SB-10052809-1509

Title: Reinforcement of the Battery Box CE RE FE and BE Buses

Applies To: Model: Bus Start Date: 03/09/1999 End Date: 12/12/2006

Before Repair

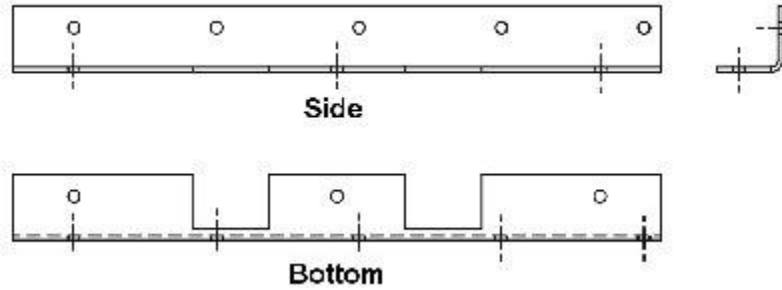
On some bus models the bottom of the battery box may deform, or begin to separate from the sides of the box under the weight of the vehicle's batteries. A field kit that contains two corner supports and fasteners, for reinforcement of the battery box is now available to address this issue.

After Repair
